ADDENDUM D&A STATEMENT

Hatton Square

Information to support S73 application for minor changes as a result of detailed design development

Document number: 203-A-REP-PC-03_01

Location of existing windows in retained elevation

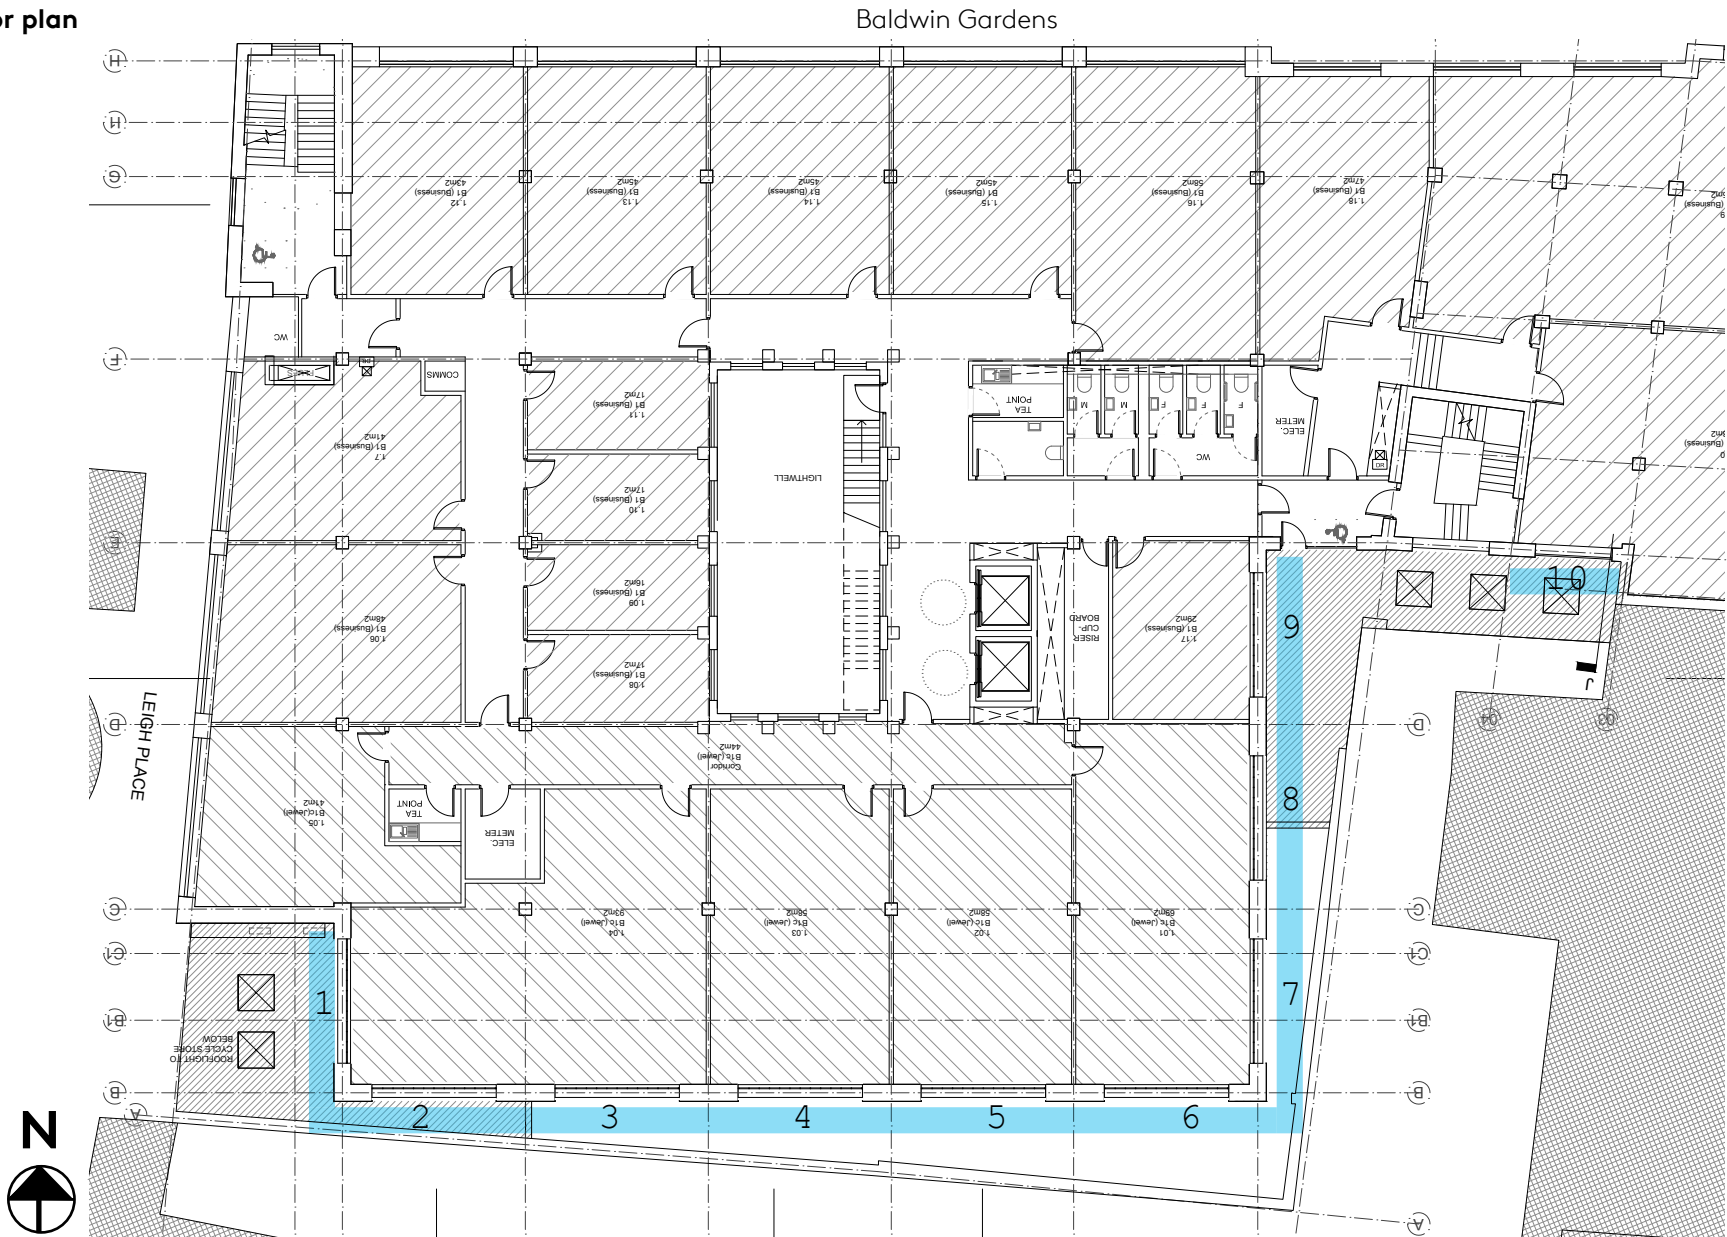
Windows to the rear retained elevations:

It is proposed to replace the existing windows with new high-performance double glazed windows in the existing openings to a specification matching the windows proposed within the new façade areas.

The existing windows to the rear and side elevations are a mixture of old single glazed multi-panel metal frame windows and later aluminium/PVC replacements - see overleaf for photographic survey.

This proposal was based on the assumption that replacement steel framed windows could be installed within the existing openings. However detailed design investigation has proved this not to be possible if the project is to meet the required sustainability performance: where new windows are installed in existing openings the minimum requirement is as stipulated by Building Regulations Part L2B is to achieve 1.8W/m2k.

The opening area of these windows is limited to small pivoting central sections. The pivoting sections prevent the installation of secondary glazing that would improve the thermal performance of the windows (currently with an estimated U-value of 6.00W/m2k) as this would restrict the already limited opportunity to naturally ventilate the interior spaces.

These are high performance double-glazed composite windows with a typical U-value of 1.3W/m2K, exceeding the U-values required by the Building Regulations and therefor helping to reduce energy loss and heating requirements.

Window Studies: proposed elevations

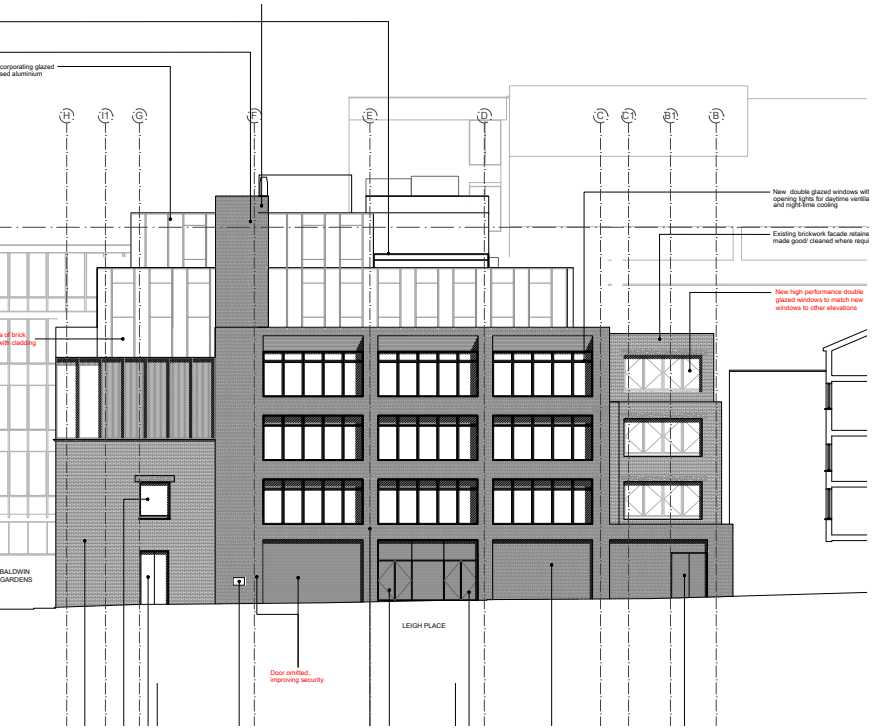
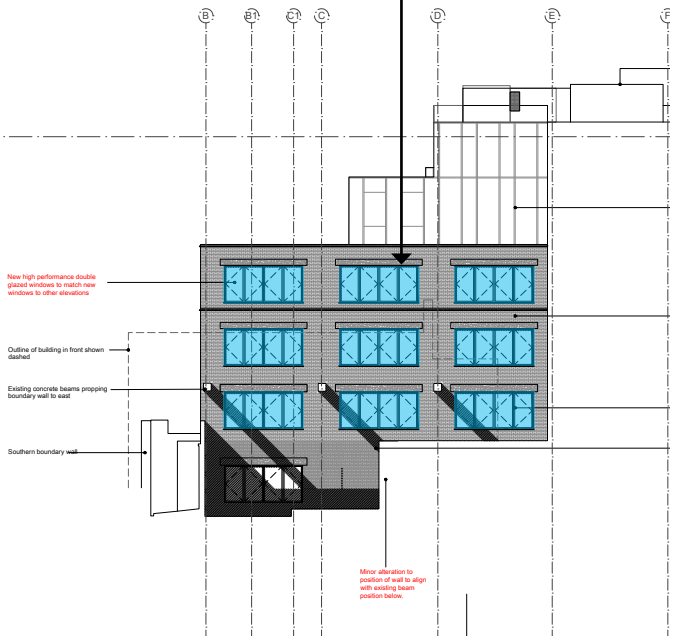
Existing & new window openings - all proposed (and consented) with high performance double-glazed composite windows with an aluminium outer face; finish natural anodised

Highlighted areas indicate openings where the existing crittall-type windows are proposed to be replaced with a matching window specification to the rest of the building - improving thermal performance and creating a more unified visual appearance

Window Studies: condition of existing frames

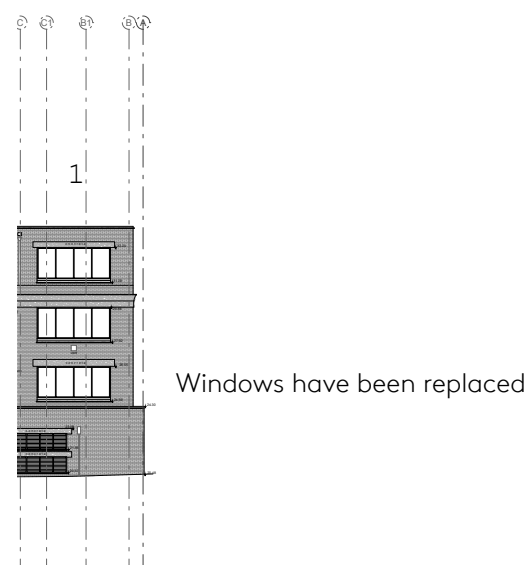
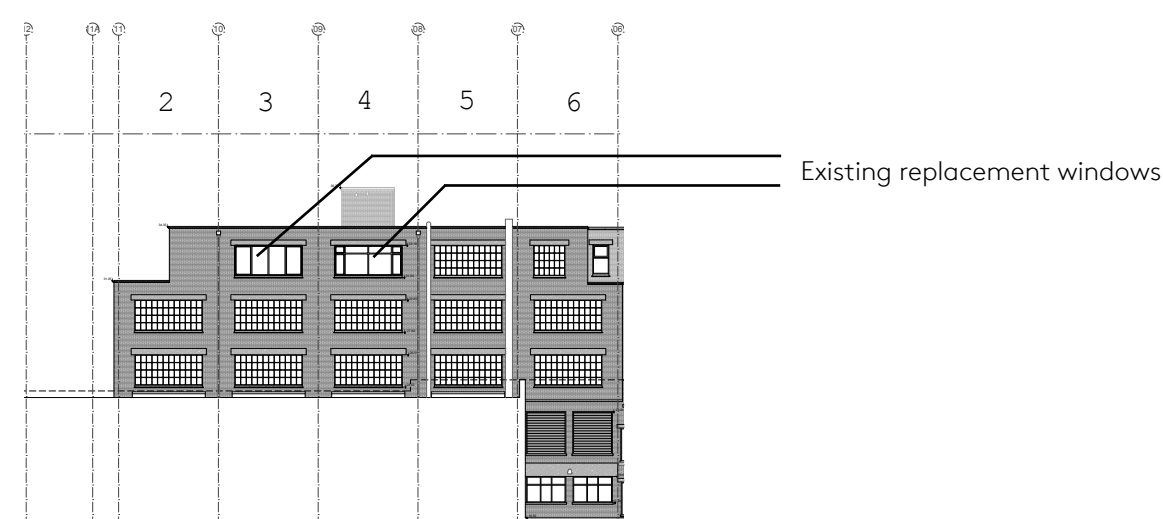
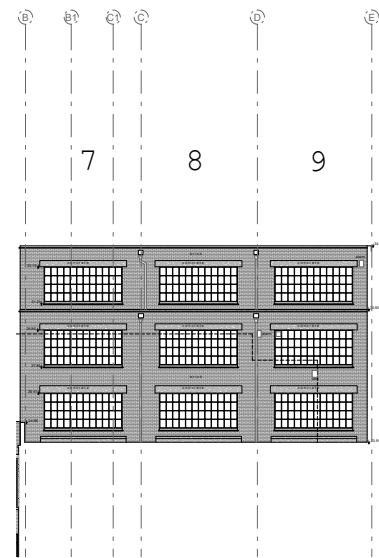
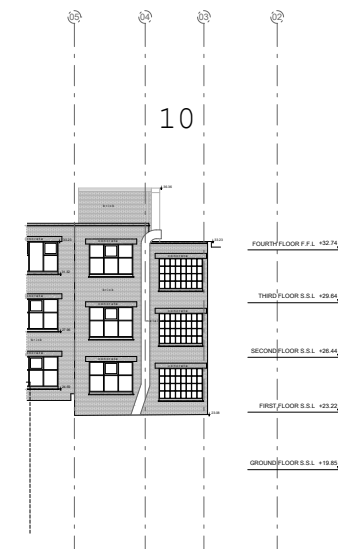
The frames of the existing windows have degraded to a poor quality over time, making them difficult to repair fully.

The frame depths of the windows are too thin to be able to replace the existing glass with new double glazing, limiting the level of improvement to thermal performance that can be made.
